# TOWN OF LOS GATOS

**PLAN CHECK COMMENTS**

**SCOPE OF WORK**  
• INTERIOR TENANT IMPROVEMENT (E) FOOD SERVICE REST.  
- DEMOLISH EXISTING FOOD SERVICE FACILITY  
- REPLACE MEZZANINE FLOOR  
- UPGRADE (E) FACILITIES TO COMPLY W/ HEALTH DEPT.  
- NO STRUCTURAL CHANGE - NO LIGHTING CHANGE W/ DINING RM  
• APPLICABLE CODES  
UPC, UMC, UPC 1994, NEC 1993  
ENERGY STANDARD 1995  
ACCESSIBILITY STANDARD  
CITY OF LOS GATOS REGULATIONS  
E-CODES.

PROPOSED TENANT IMPROVEMENT 151 N. SANTA CRUZ LOS GATOS - CA

Date: 4.20.98  
Scale:  
Drawn:  
Job: 7809  
Sheet: 11

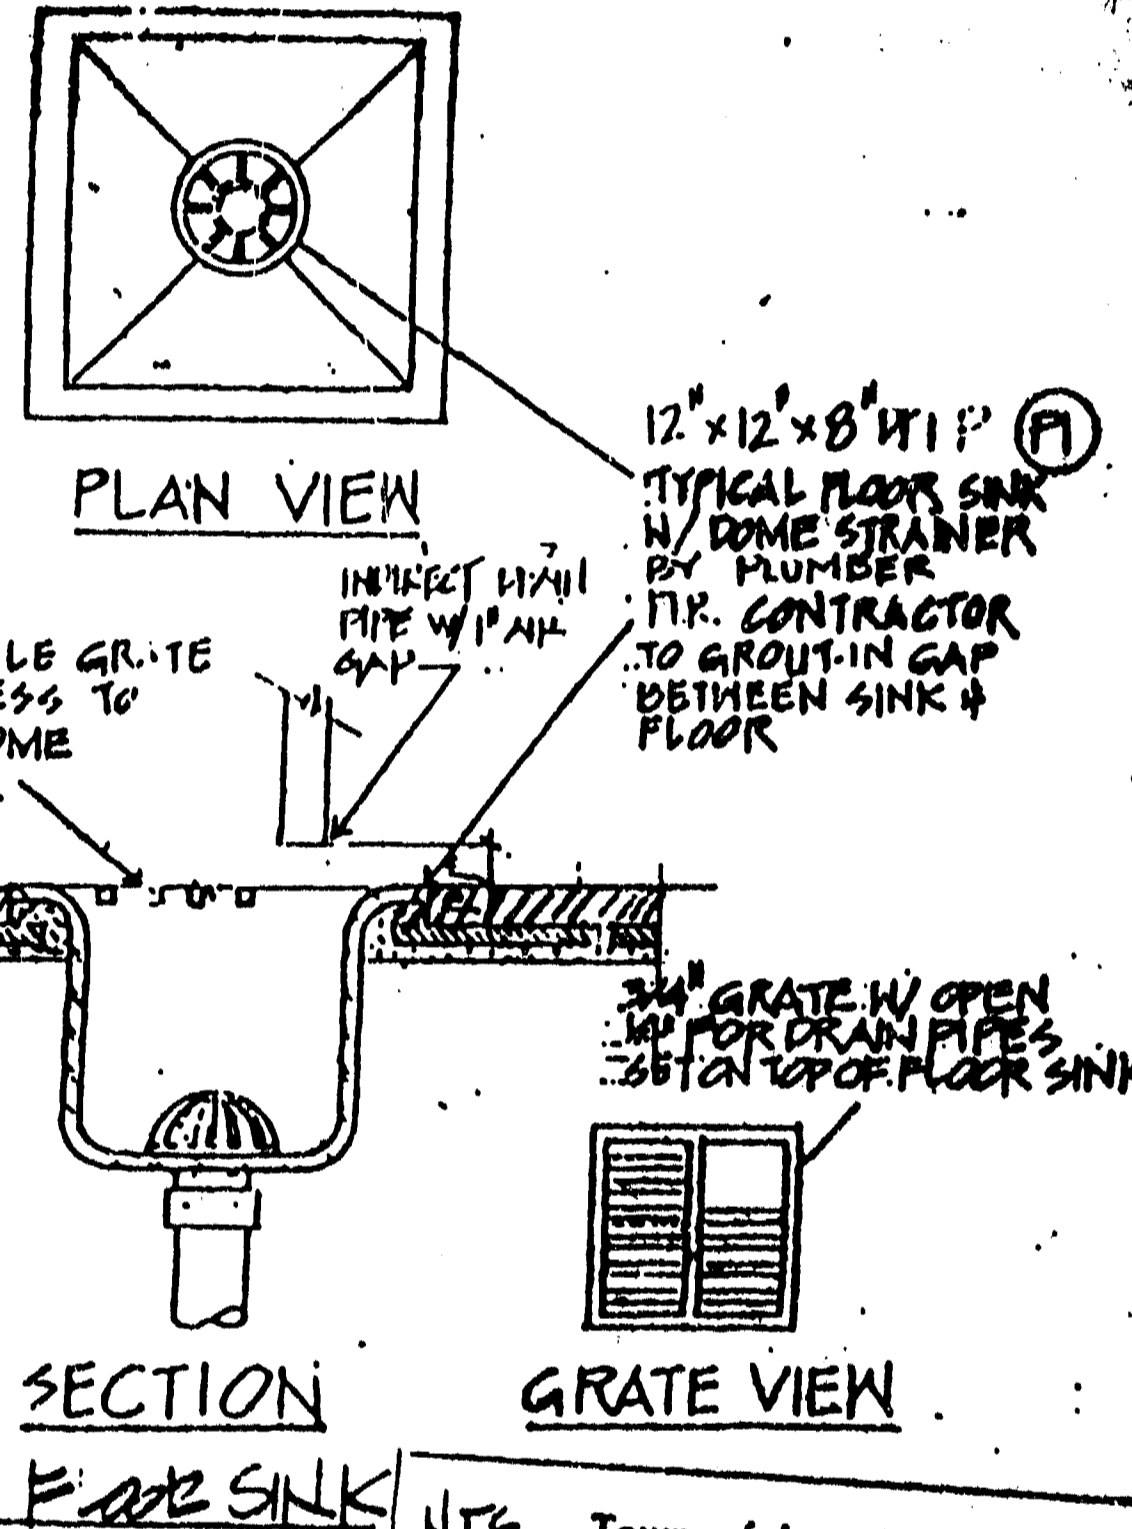
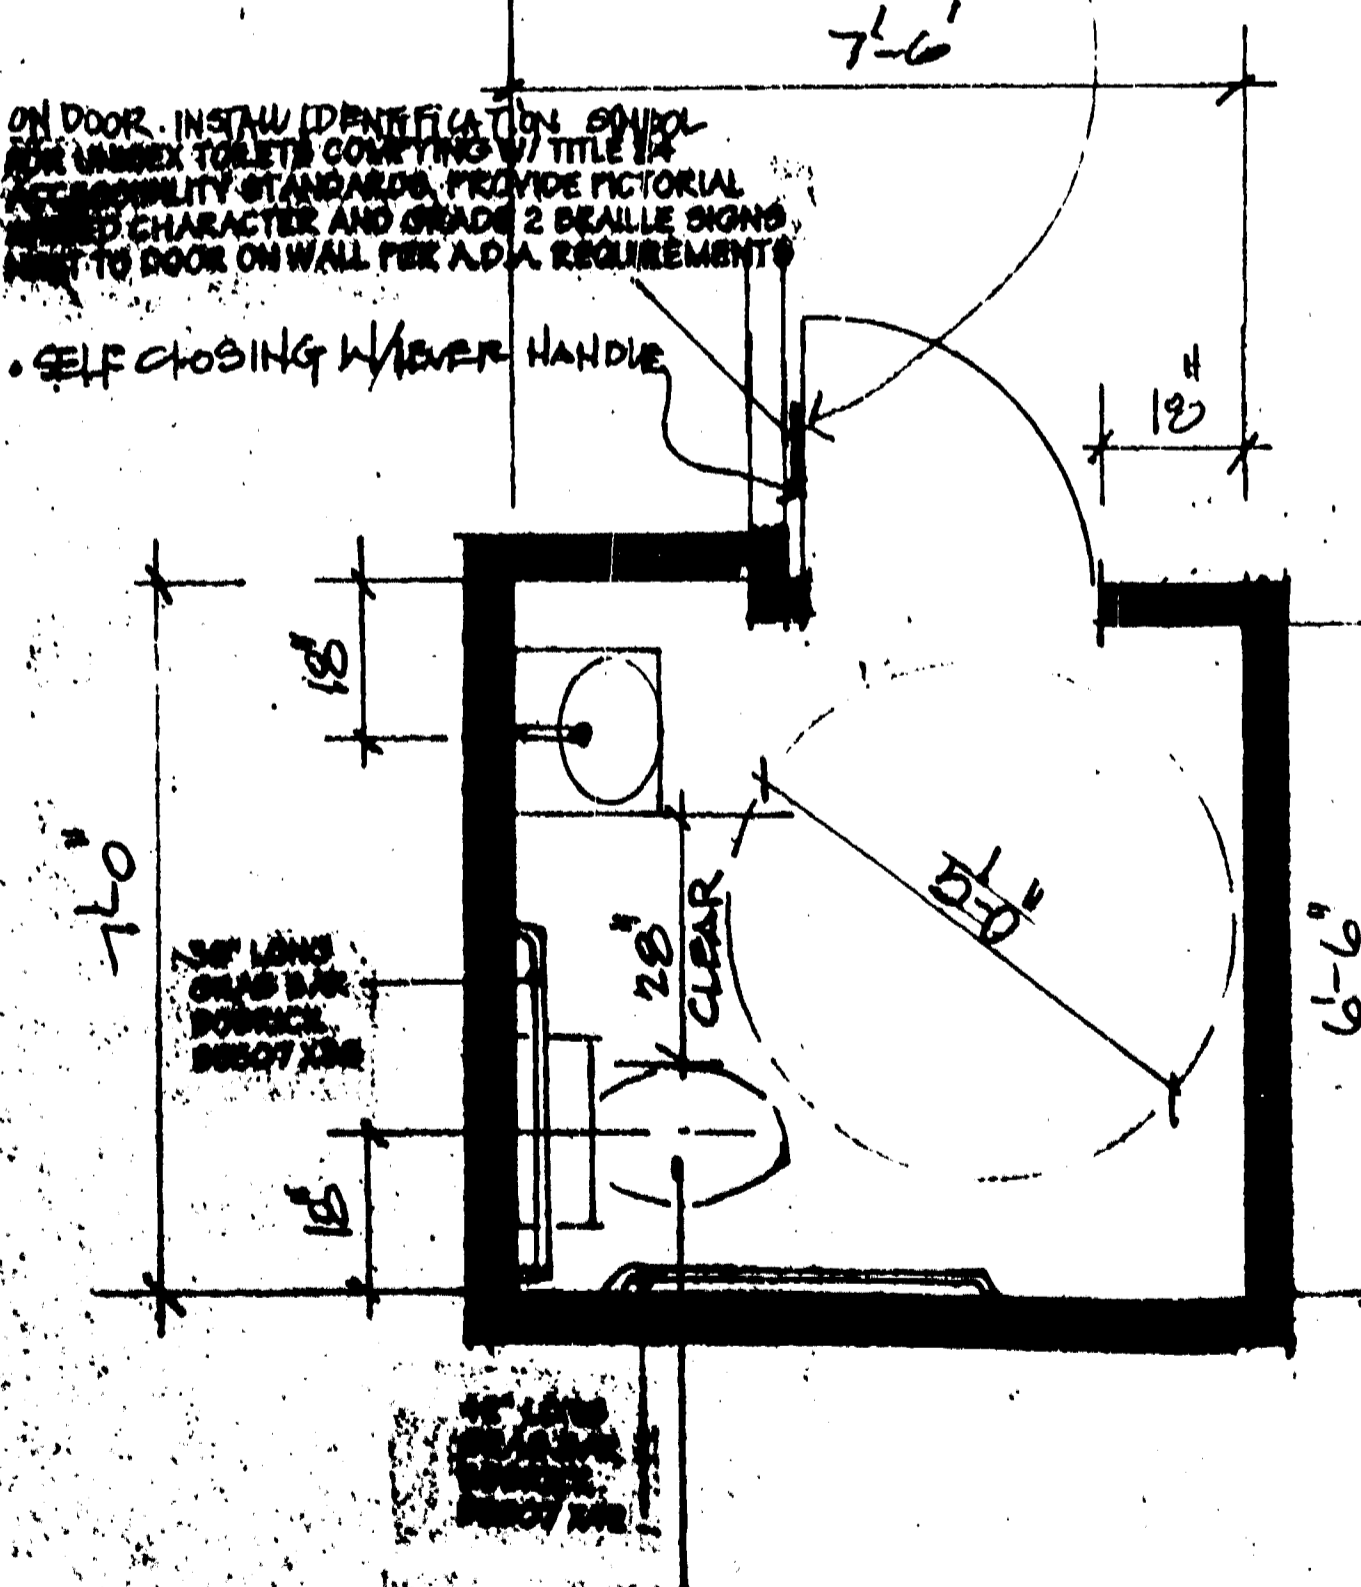
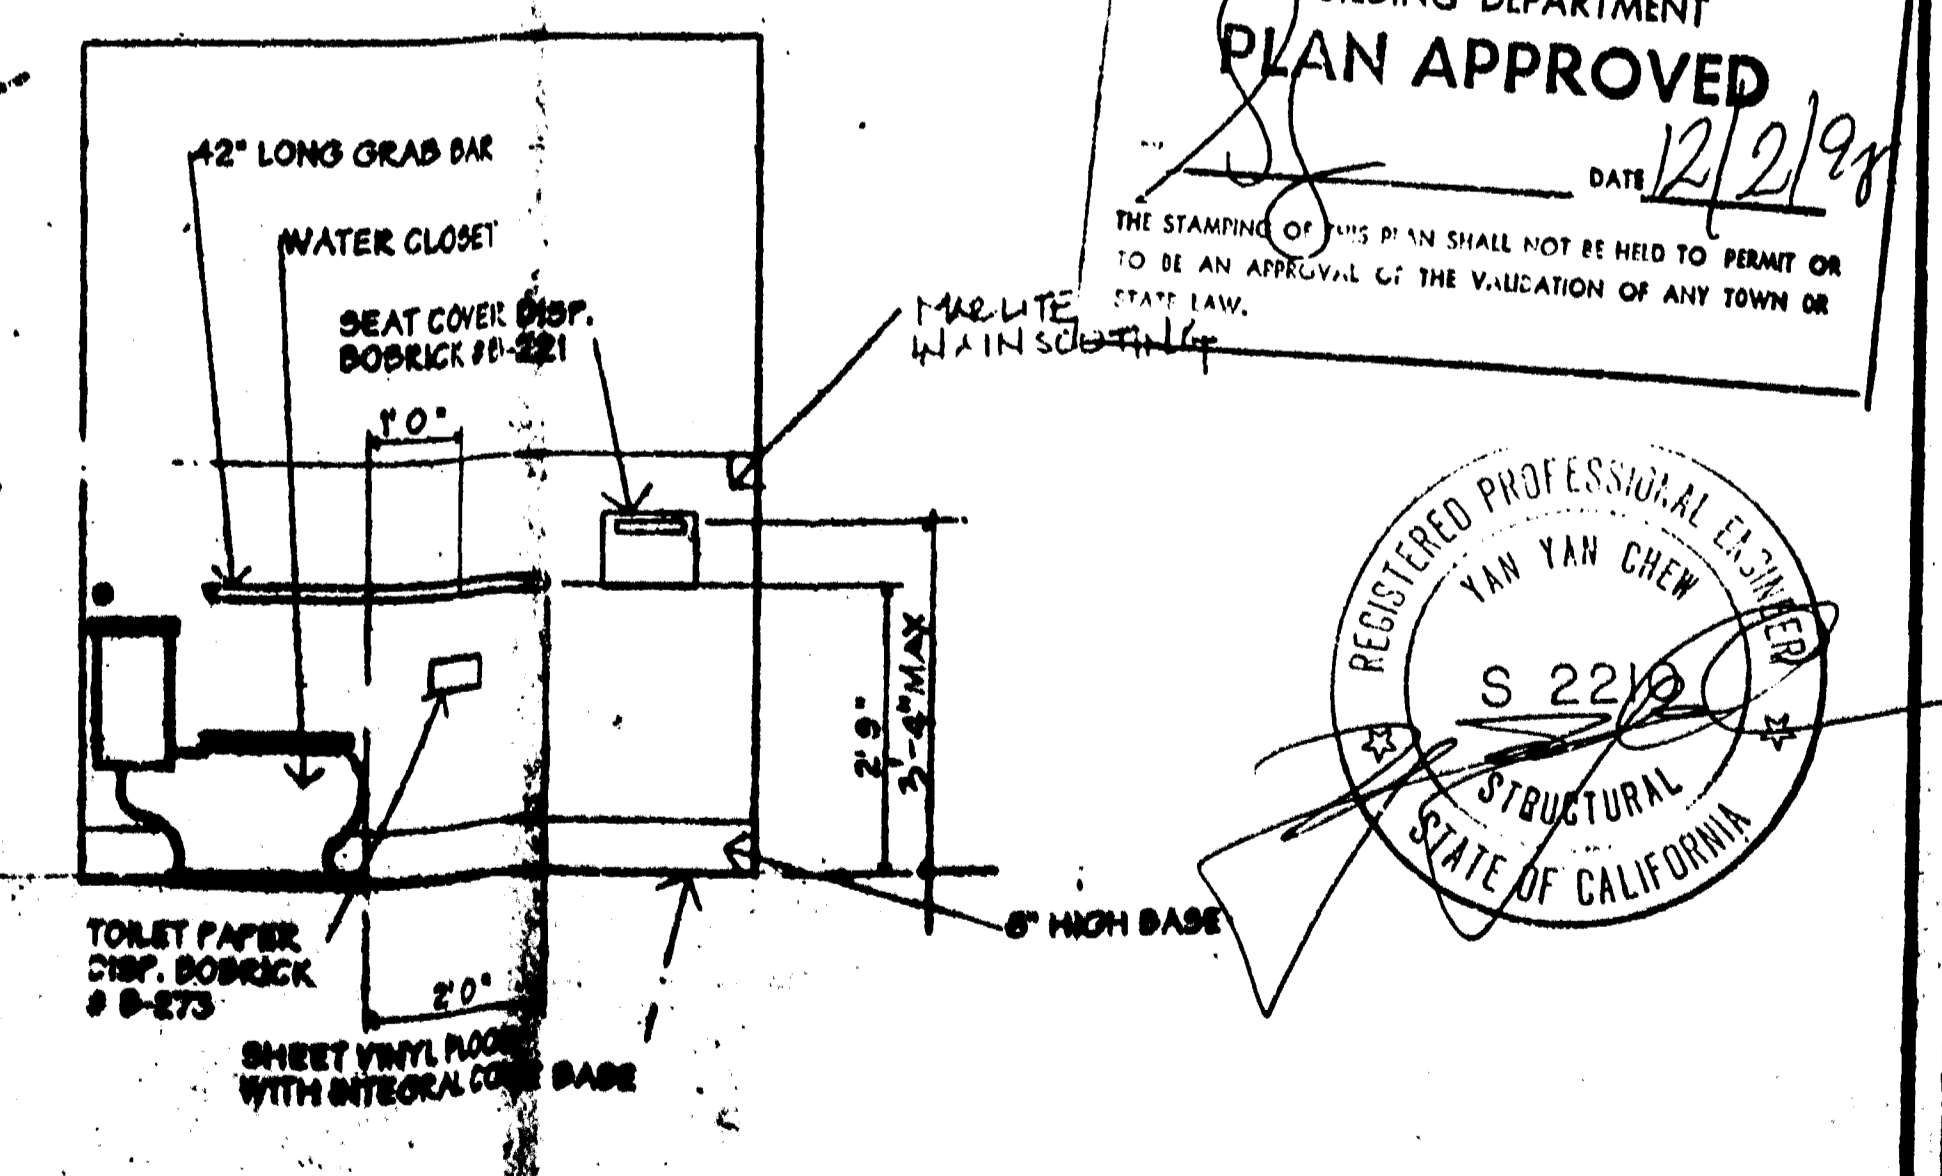
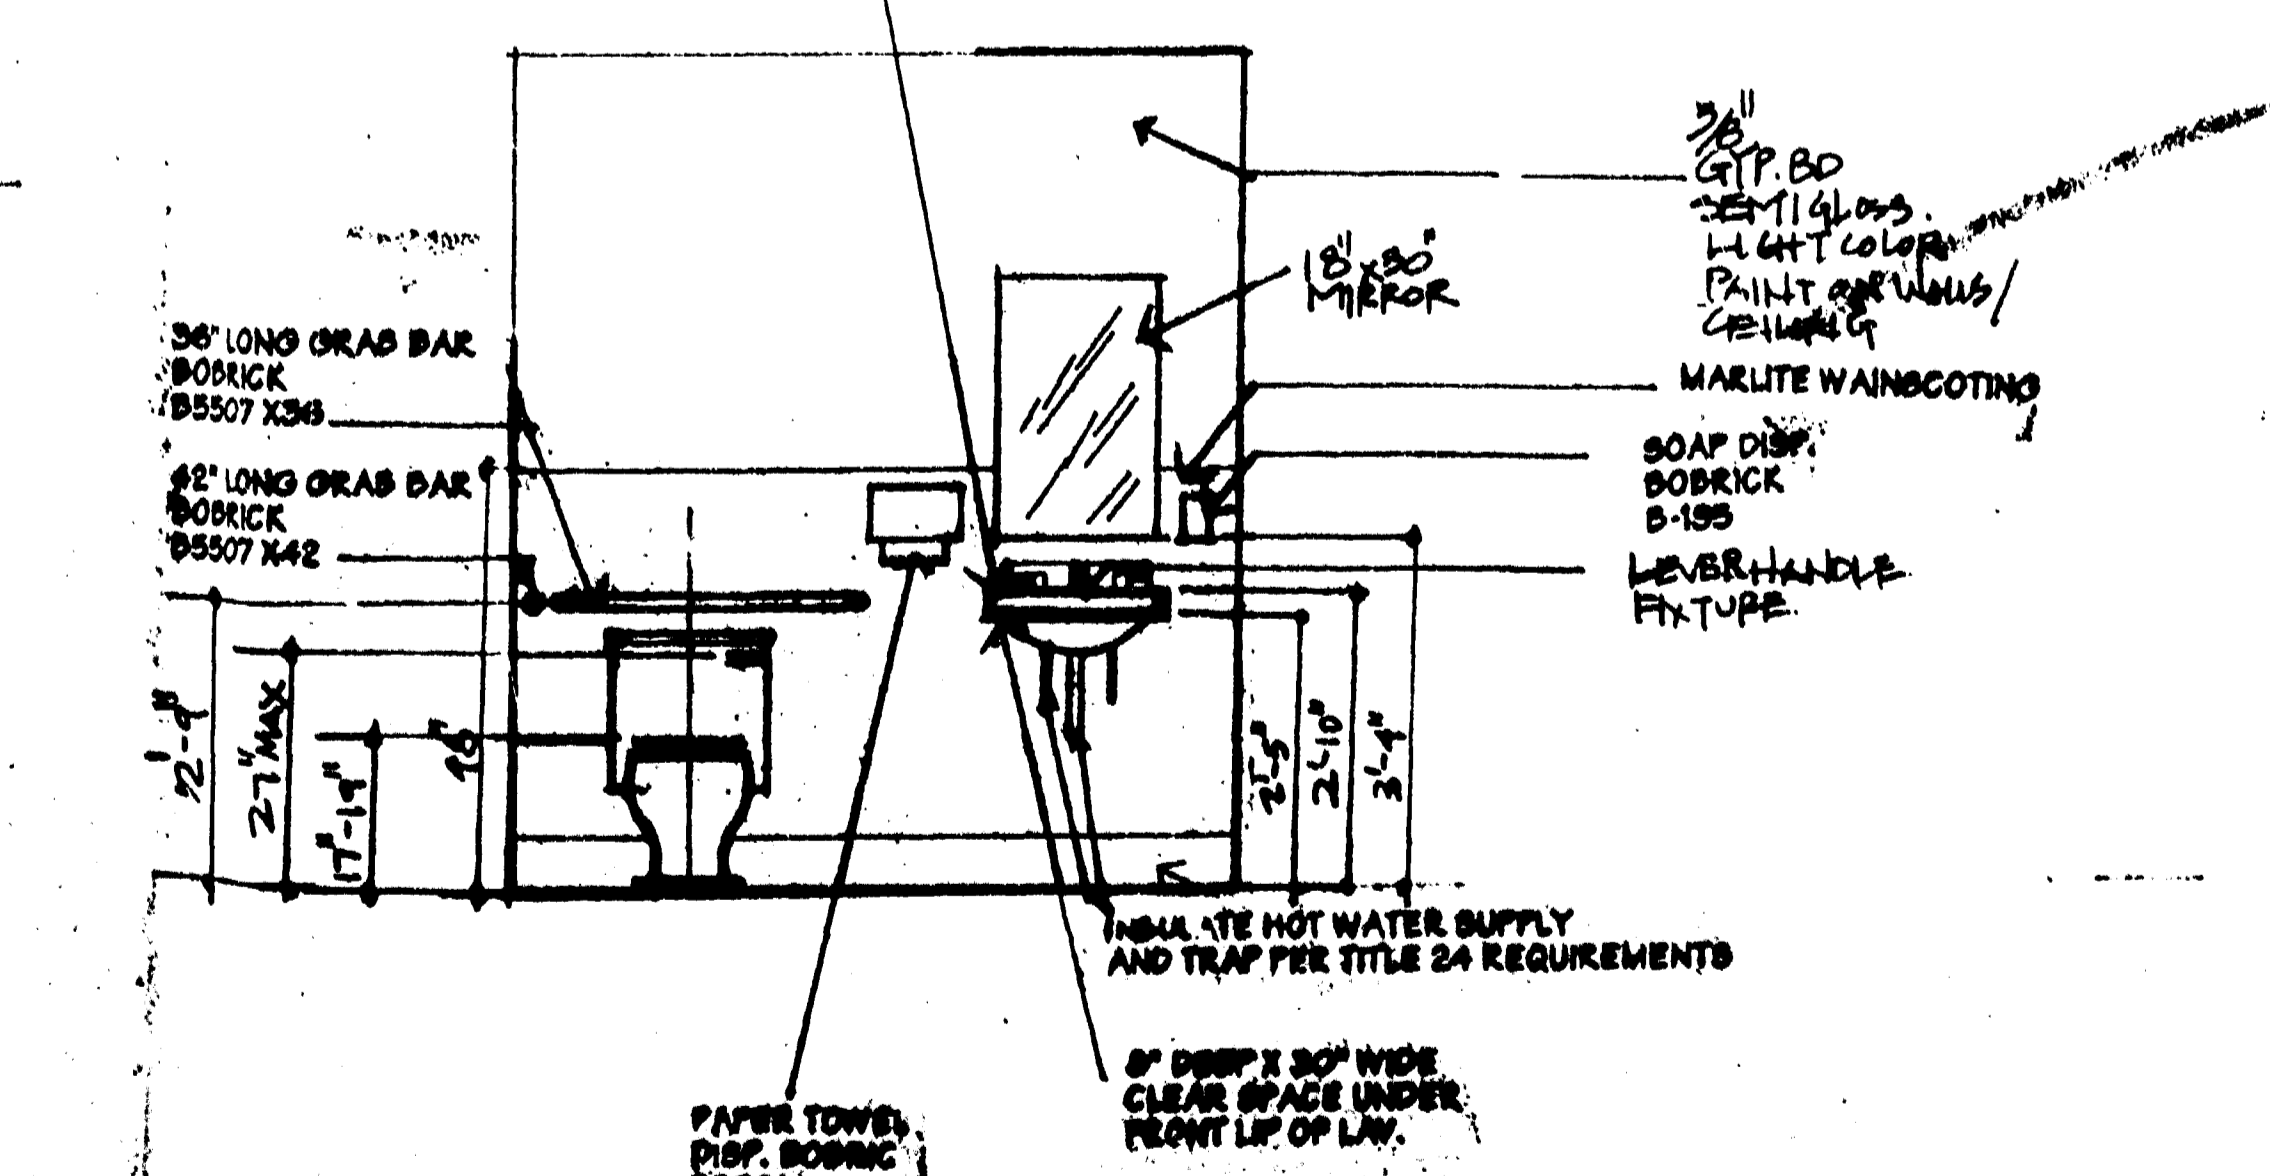
13. Revise the door hardware detail on sheet 5 and the storefront detail on sheet 12 to show 60" from the ground surface to the centerline of the accessibility sign (not 48"), as required per CBC Section 1127B.3.

18. Note on the bathroom detail that the grab bar diameter shall be between 1-1/4" and 1-1/2", as required per CBC Section 1115B.8.2.
19. Revise the plans to show location of accessible counter at the cash register (minimum 36" long, between 28" and 34" high), as required per CBC Section 1122B.4.

1. SHEET 7 - 12
2. SHEET 1
3. SHEET 2
4. SHEET 2
5. SHEET 2
6. SHEET 2
7. SHEET 2
8. SHEET 2
9. SHEET 2
10. SHEET 2-4
11. SHEET 5
12. SHEET 5
13. SHEET 5
14. SHEET 5 / SHEET 12
15. SHEET 5 / SHEET 12
